Joseph Garruba  
 28 Winchester Dr.  
 Hollis NH 03049  
 September 16, 2021

Members of the Hollis Planning Board

I am writing to point out several problems with the plan set submitted by the developer for the 50 unit condo development at 365 Silver lake Rd. The developer submitted a site plan titled Condominium site plan revised Sept 7 2021. This plan is on file in the town offices. The comments below address this plan set specifically

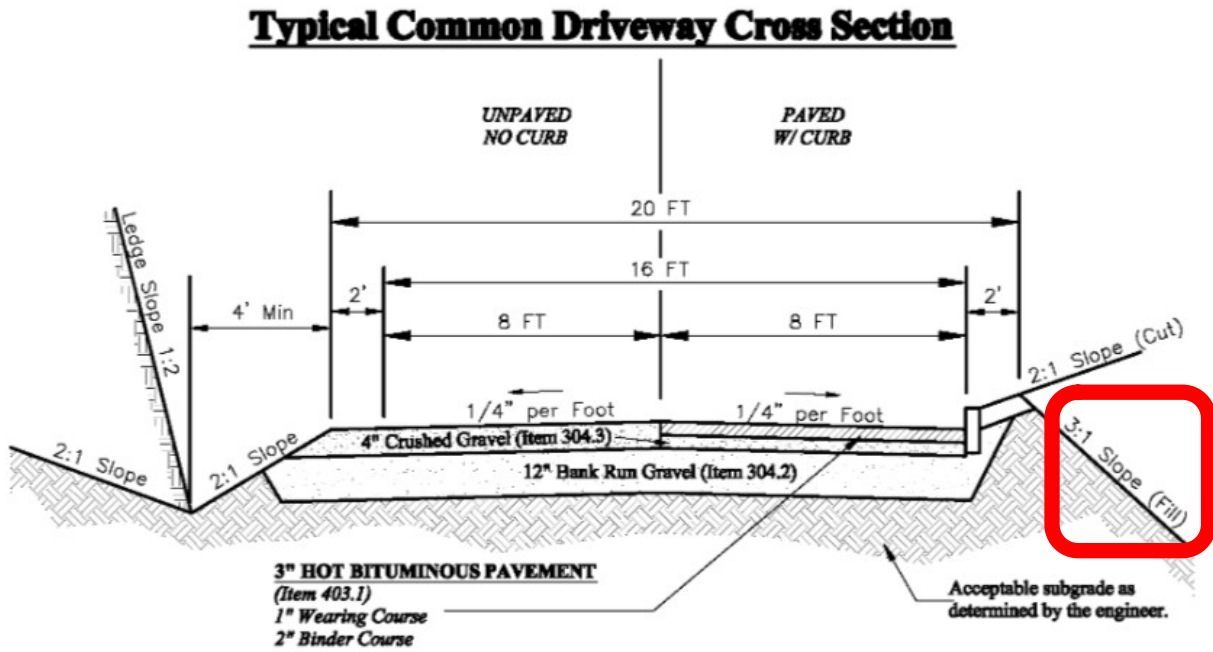
2 The plans show intersections in the loop road in three locations. Each of these is a T intersection with 3 legs. The town engineer has previously confirmed that all legs of an intersection are required to have <3% Slope within 150 feet

Loop Road Station	10 +75	Exact elevations needed to confirm slope
Clubhouse Station	11 +60	at least 1 leg with 6% Slope is not compliant
Spur Station	27+70	2 legs with 6.2% Slope are not compliant

This requirement is clearly stated in the road standards of the subdivision regulations in the table of geometric standards as item #7 Maximum Grade 100' from intersection: 3%

The developer claims this is for legs with stop signs only but there is NO support for this claim. The town of Hollis regulations are permitted to be more strict than state standards and more strict than the AASHTO design guidelines. Arguments based on those standards do not relieve the developer from requesting a waiver from the clear Hollis regulation. The board needs to follow up clearly on its statement that this project will not be permitted waivers. If the road does not comply it should be redesigned to be compliant with the understanding that units may need to be removed in order for the roadway design to be compliant
